Memorandum

**Summary of VHB Responses to PS 21 Comments of 2-3-2017 on Islington St Design:**

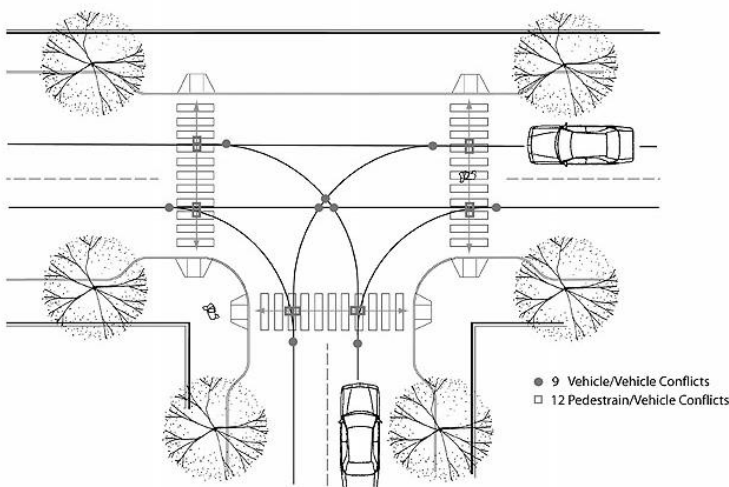
c. By "Dentist" near Albany (Sta 122+50 Rt), the sidewalk is inadequate despite significant encroachment into the right-of-way.

Response: The head-in parking would need to be eliminated to build a sidewalk of adequate width to support pedestrians, utilities and snow removal. The current solution maintains the parking and defines a raised median for the lights and utilities. Pedestrians would walk within the driveway, much as they do today, except the walkway will be striped.

## Bank driveway modifications:

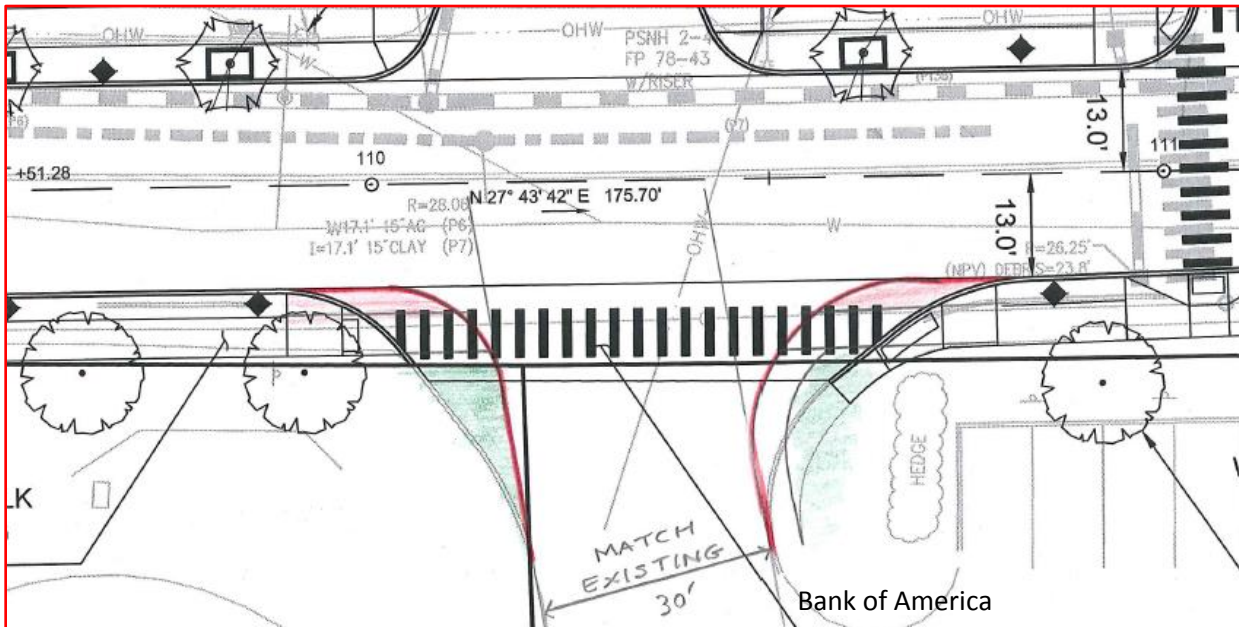
i. *The entrance at "Bank of America" (Sta 110+25 Rt) appears to be 40 feet wide*

Response: The existing two-way drive appears to have been designed for trucks, but the site does not currently appear to need regular truck access. The internal drive width is 30 feet and we can extend that toward the roadway to narrow the existing opening. See the attached sketch.

**White Heron and Sunoco Drive Modifications:**

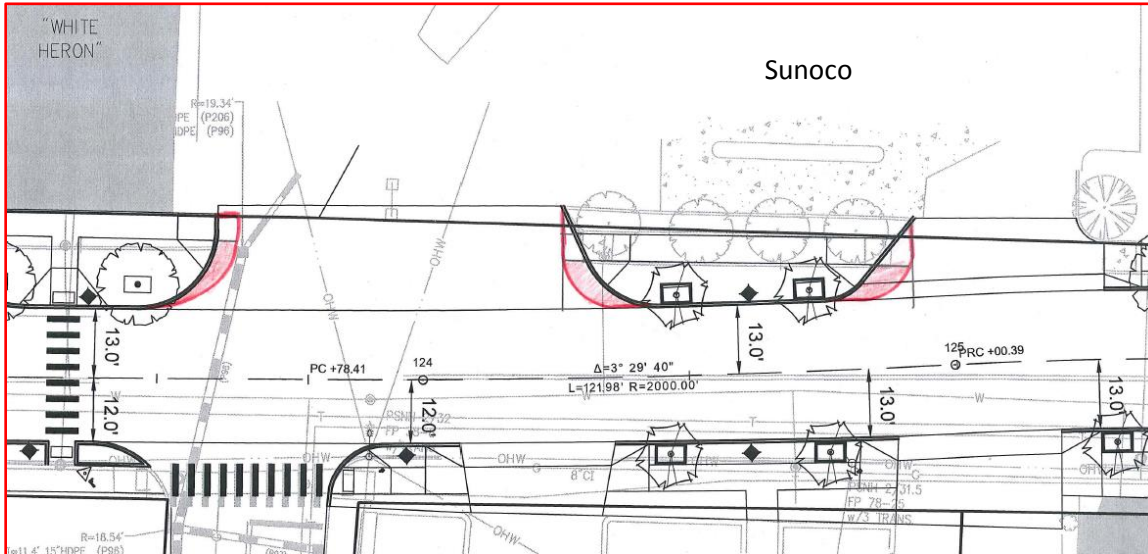
m. *Can anything be done about the extremely wide curb cut between "Sunoco" and "White Heron" (Sta 124+00 Lt)?*

Response: They function as two drives. We can tighten it up a little as shown on the attached sketch.

**Cass Street Bumpout and Crosswalk Improvements (Lose 1 space):**

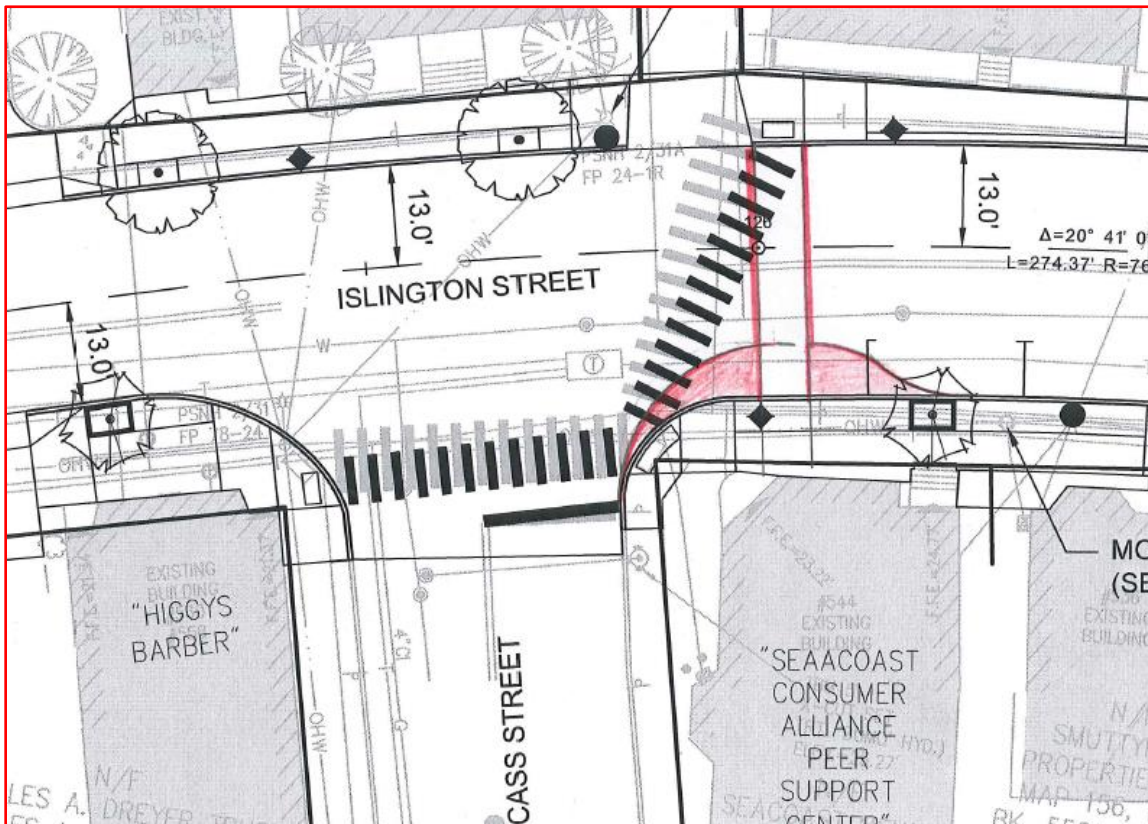
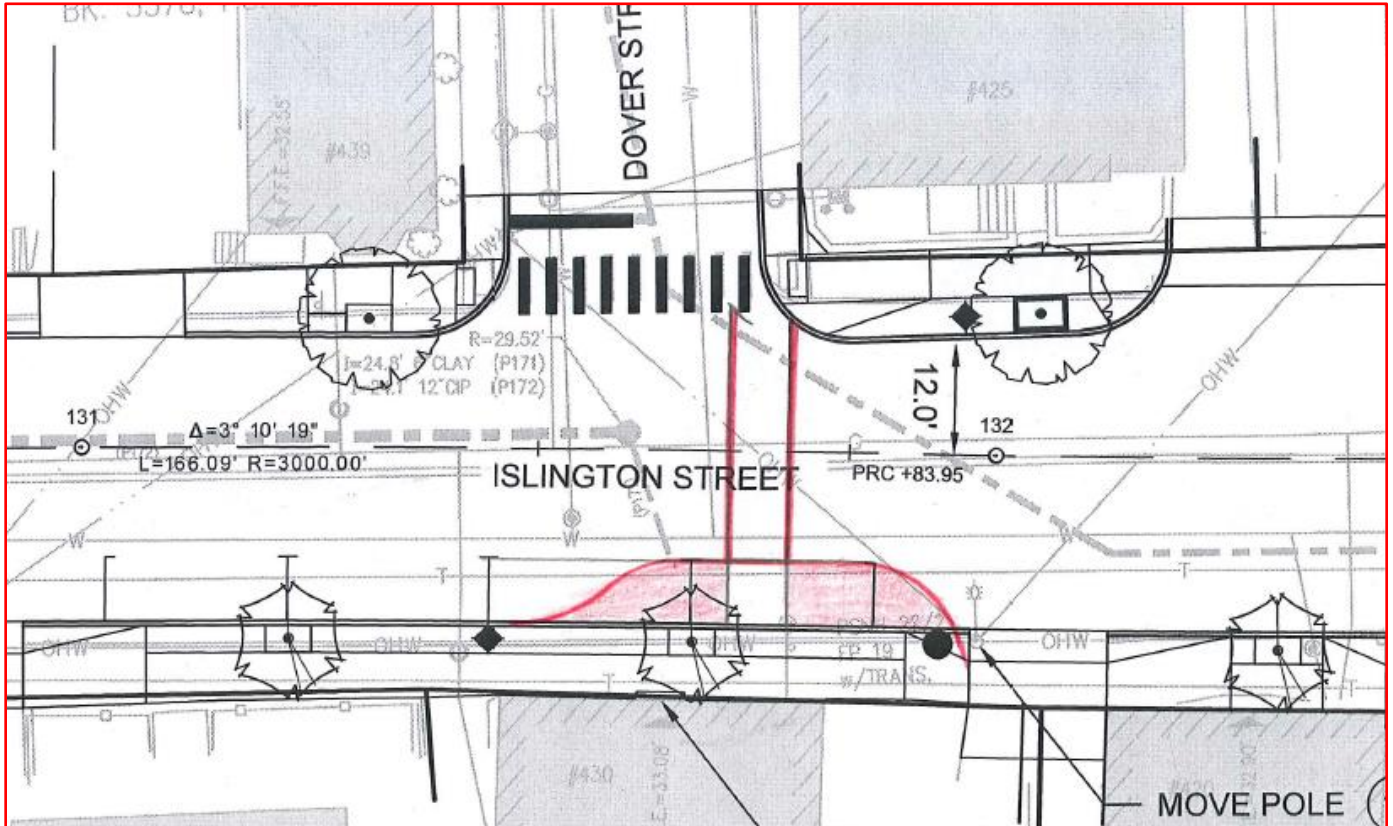
**Cass Street:** Propose adding a bumpout and realign the currently proposed crosswalk to 90 degrees. Lose 1 parking space.

**Dover Street Bumpout and Crosswalk (Lose 2 spaces):** (The City elects not to install this crosswalk)

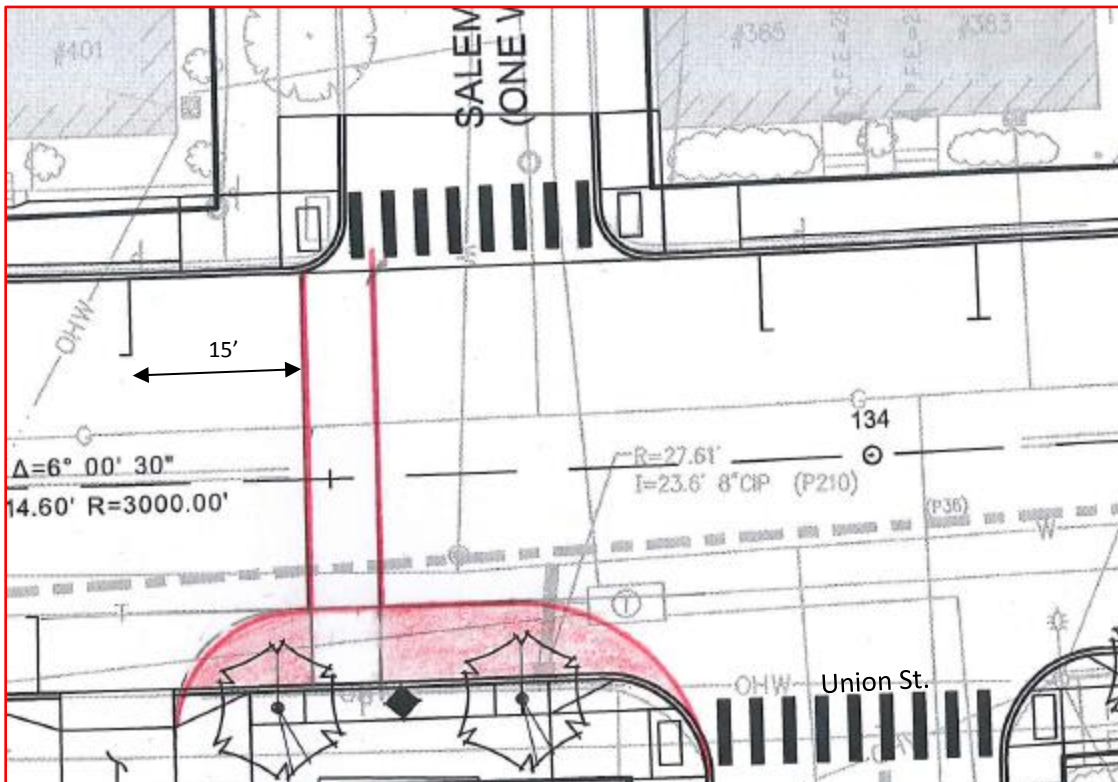
**Dover Street:** Bumpout and crosswalk can be added. Lose 2 spaces. City prefers no change.

**Salem/Union St Intersection: Add crosswalk & bumpout.** (The City elects to keep the parking space even though 15' from crosswalk)

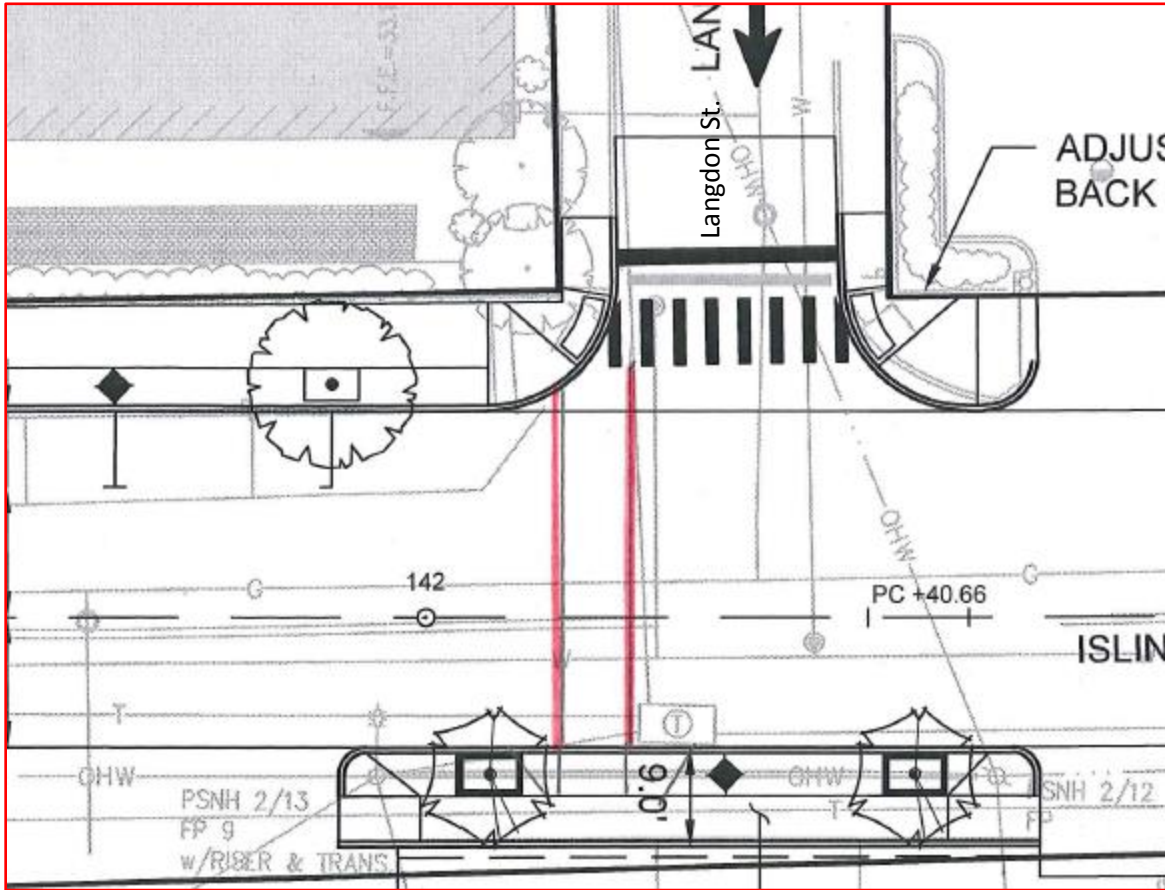
**Salem/Union Streets:** Bumpout and crosswalk can be added. No loss of parking.

**Langdon Street crosswalk addition. (No lost spaces)**

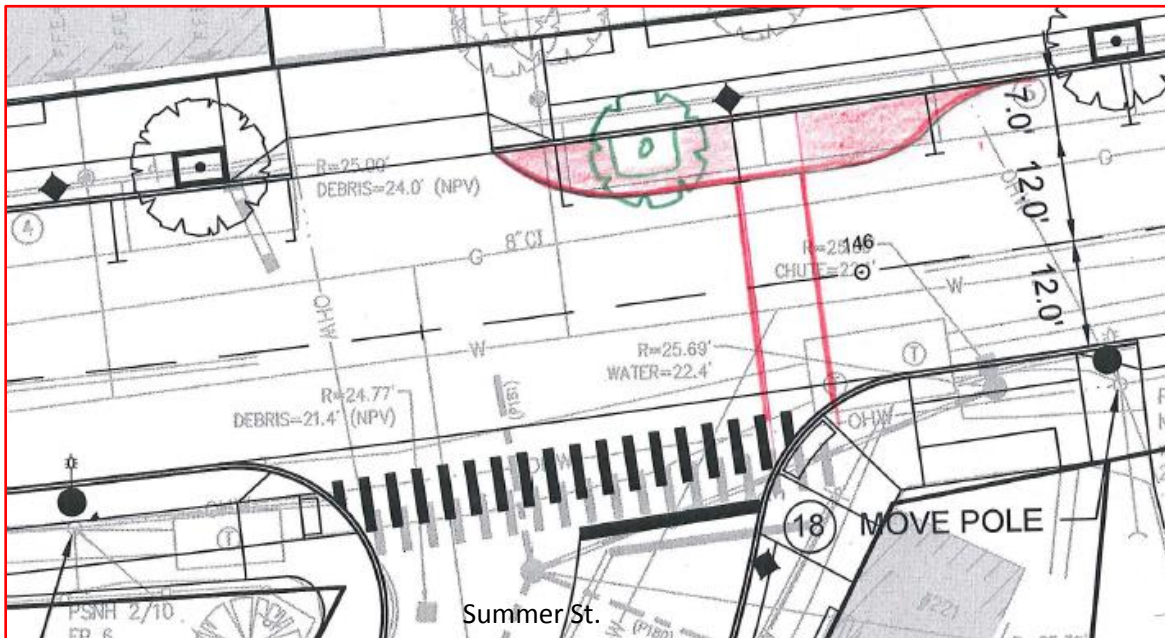
**Langdon Street:** Crosswalk can be added. No bumpout or loss of parking.
